AURIX™ TC37x errata sheet

Marking/Step: (E)ES-AA, AA

10525AERRA

Figure 14 Positive overload on P-pad of a LVDS RX pin pair (both used as inputs)

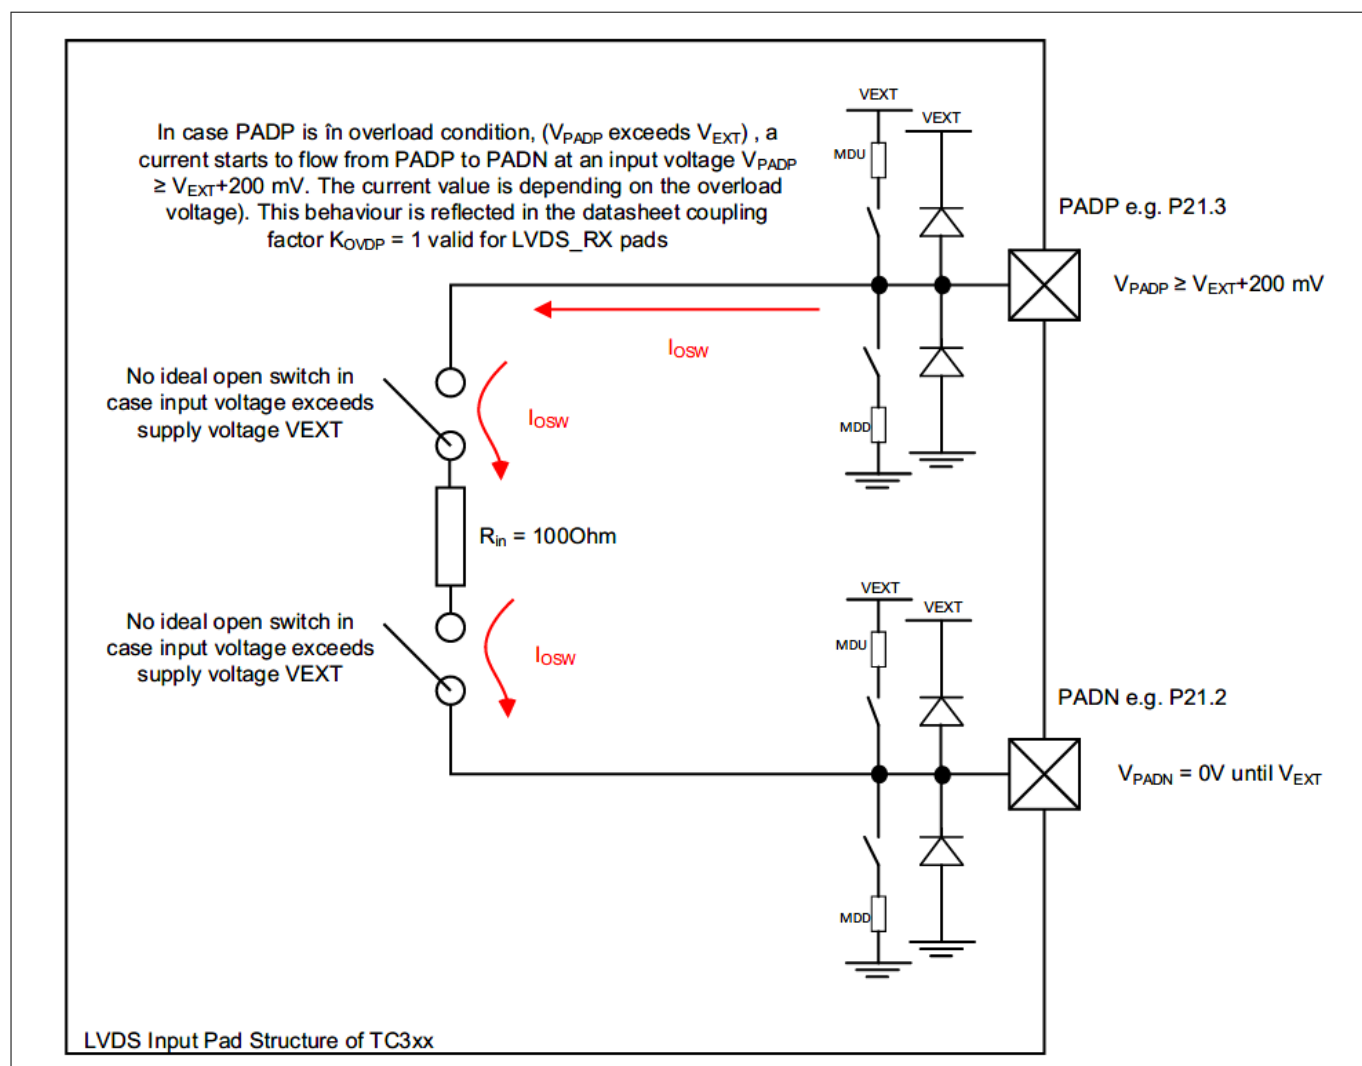
The overload current I_{OSW} through the non-ideal open switch significantly increases when $V_{PADP} \geq V_{EXT} + 200 \text{ mV}$.

Note: In general, the effect will also occur if the N-pad is used as output, or for a negative overload condition on either the P-pad or the N-pad.
